Access Compliance Report

Public Rights-of-Way

(Curb Ramps)

Intersection ID: 44072	Main Street: SEDGEMOOR_LN	Cross Street: OVERSTONE_CT	Location: NE
ADA ID: CBAF5DC8BE98	Ramp Type: BlendTrans1	Initial Pass/Fail: Fail	Overall Compliance: No
			Severity Score: 21.25

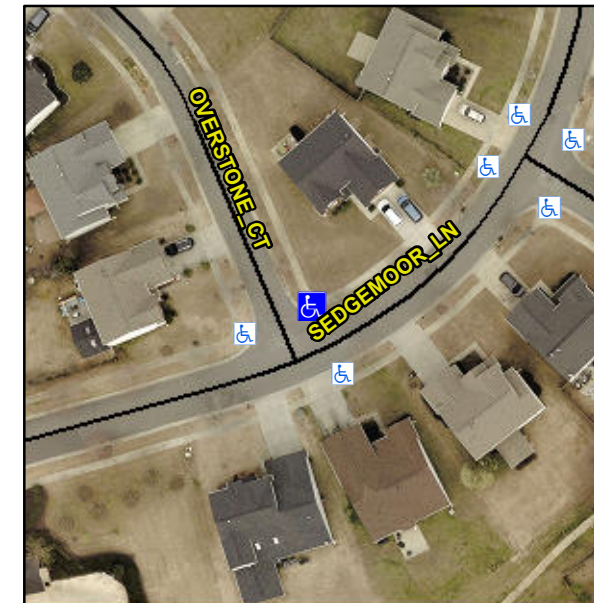
R304.5.1, R304.5.3

Compliance	Description	Data	Compliance	Description	Data
N/A	Ramp Length (in)	68.0	Yes	BlendTrans Slope (%)	4.2
No	Ramp Width (in)	42.0	No	BlendTrans XSlope (%)	6.7
N/A	Flare Type LT	N/A	N/A	Flare Type RT	N/A
N/A	Flare Slope LT (%)	N/A	N/A	Flare Slope RT (%)	N/A
N/A	Flare Traversable LT?	N/A	N/A	Flare Traversable RT?	N/A
N/A	Landing Length (in)	N/A	N/A	DWS Provided?	N/A
N/A	Landing Width (in)	N/A	N/A	DWS Contrast?	N/A
N/A	Landing Slope (%)	N/A	N/A	DWS Length (in)	N/A
N/A	Landing X Slope (%)	N/A	N/A	DWS Full Width?	N/A
N/A	Landing Curb? (Y/N)	N/A	N/A	DWS Offset (in)	N/A
N/A	Shared Landing?	N/A			
N/A	Gutter Ponding?	N/A	N/A	Gutter Slope (%)	N/A
N/A	Gutter Lip Ht (in)	N/A	N/A	Gutter X Slope (%)	N/A
N/A	Painted X Walk1?	No	N/A	Painted X Walk2?	No
	X Walk 1 Direction	To SW		X Walk 2 Direction	To SE
	X Walk 1 Width (in)	N/A		X Walk 2 Width (in)	N/A
	X Walk 1 Slope (%)	1.1		X Walk 2 Slope (%)	0.6
	X Walk 1 X Slope (%)	2.0		X Walk 2 X Slope (%)	0.6

Remove & Replace Curb Ramp With Two New Directional Ramps or Equivalent.
